**Re: Murphy Express (Unser Blvd)  
221 Unser Blvd SW  
30-Day Temporary Certificate of Occupancy  
Transportation Development Final Inspection  
Engineer's/Architect's Stamp dated 2-18-20 (DRB) (K10D061)  
Certification dated 10-8-20**

Ernie Gomez,  
Plan Checker, Planning Dept.  
Development Review Services

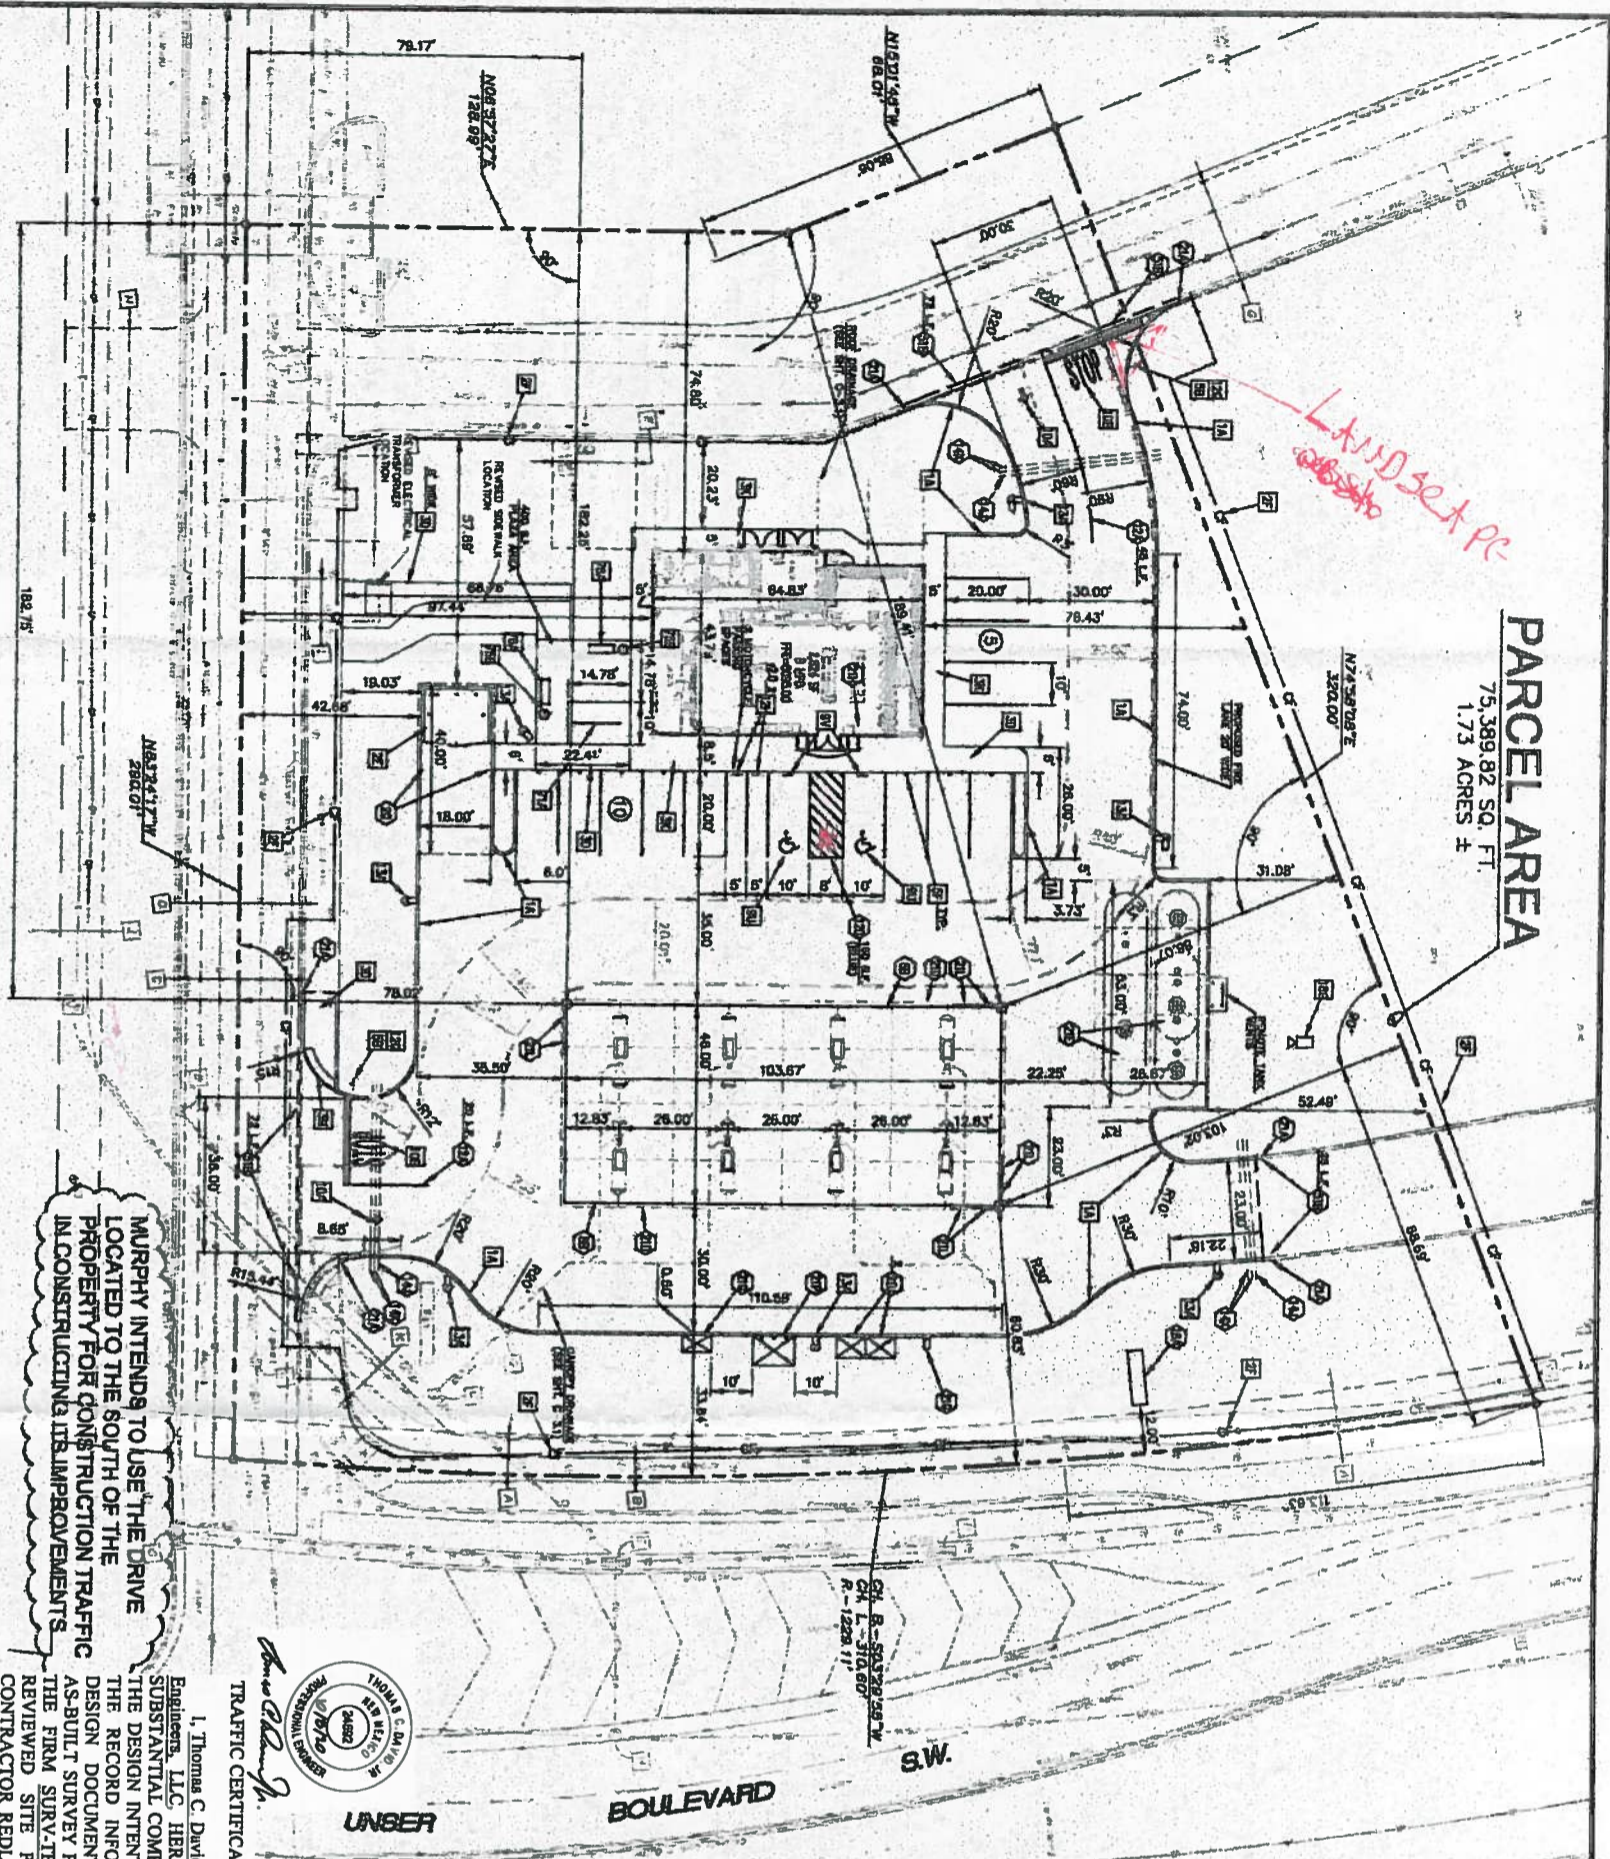
- The ADA access aisle shall have the words "**NO PARKING**" in capital letters, each of which shall be at least one foot high and at least two inches wide, placed at the rear of the parking space so as to be close to where an adjacent vehicle's rear tire would be placed. (66-1-4.1.B NMSA 1978)
- Please correct clear site. Landscape obstruction visibility. See plan for location

Once corrections are complete resubmit

1. The approved and stamped Site Plan for Building Permit with changes drawn in red.
2. Transportation Certification letter on either the plan or applicants letterhead.
3. A Drainage Transportation Information Sheet (DTIS)
4. Send an electronic copy of your submittal to [PLNDRS@cabq.gov](mailto:PLNDRS@cabq.gov).
5. The \$75 re-submittal fee for log in and evaluation by Transportation.
